**66321B-05**

# S E R V I C E N O T E

66321B

## Reliability Improvement of Instrument

**CORRECT J207 PLACEMENT** – alignment to within  $< 0.3\text{mm}$

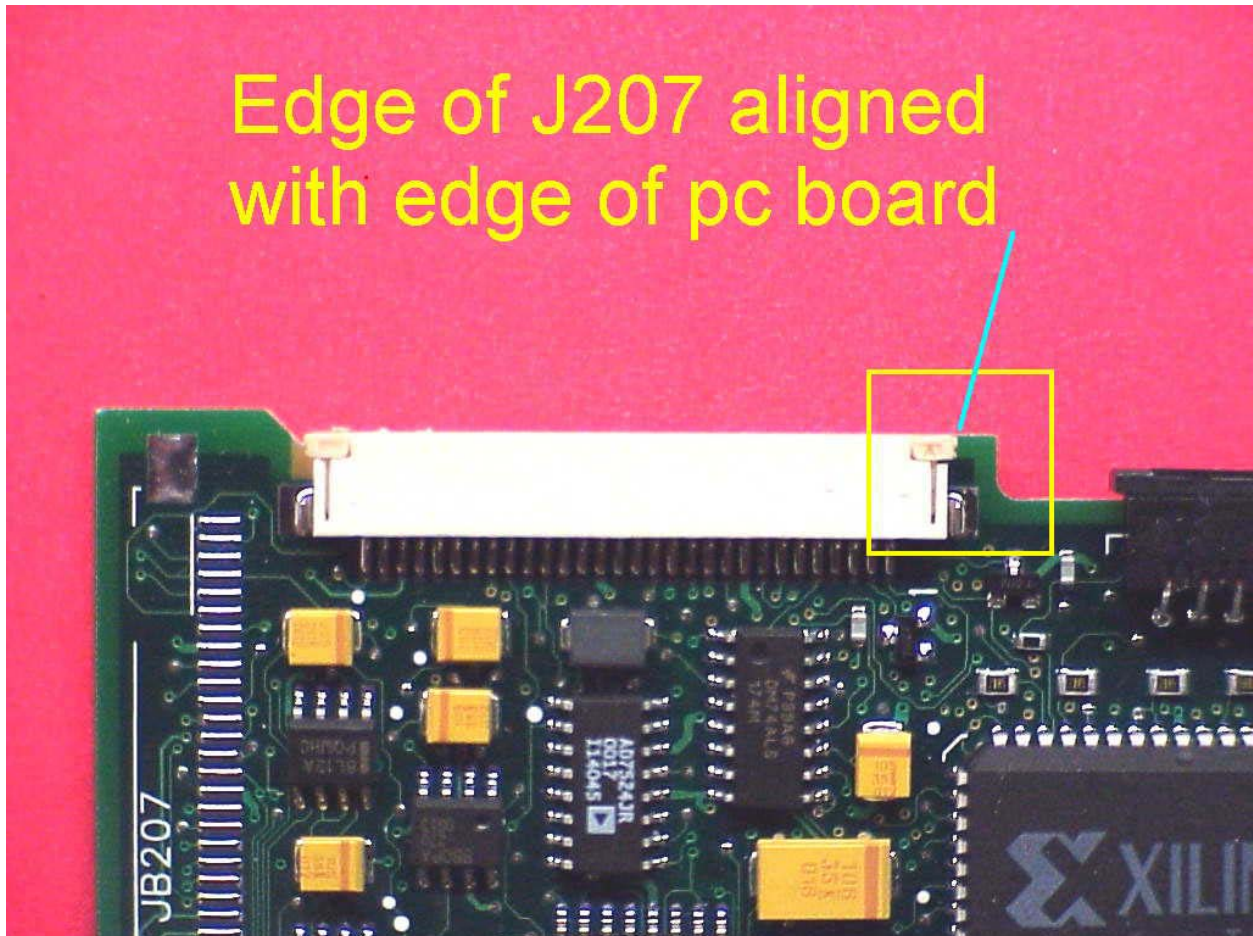
Latent product failure due to misplaced connector J207 on SMT assembly 5064-0018 (GPIB/RS232 interface). Misplacement of J207 could lead to inadvertent contact/shorting of exposed feed-throughs on SMT board. Ultimately, resulting in over-stress of components of damage to SMT board components. Resulting contact could degrade useful life of instrument.

Picture shows connector aligned to edge of SMT board to within  $< 0.1\text{mm}$

- 1) Compare placement of J207 to attached photos. Instruments with a “misplaced” J207 should be returned to Agilent for warranty repair.
- 2) Instruments returned to the Service Center for routine calibration should be inspected for this potential defect. Defects should be addressed using Agilent’s unit exchange process with costs being charged to warranty.
- 3) The factory has modified production documentation to include visual inspection and specific electrical testing for this potential short.
- 4) Factory is maintaining feedback to SMT board supplier regarding quality of assembly.

**INCORRECT J207 PLACEMENT** – misaligned by  $> 0.3\text{mm}$

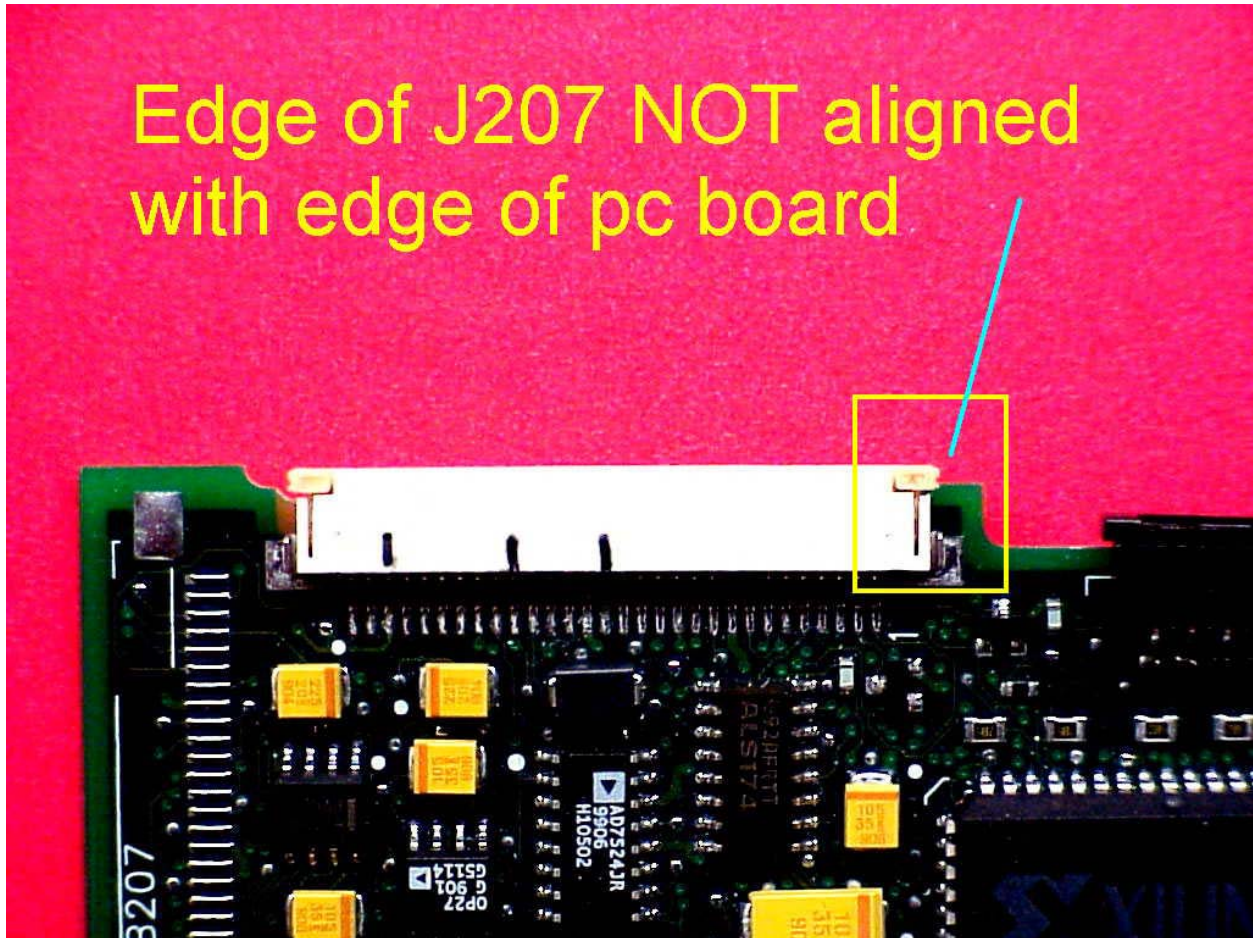
Picture shows connector extending past edge of SMT board by  $>1.2\text{mm}$
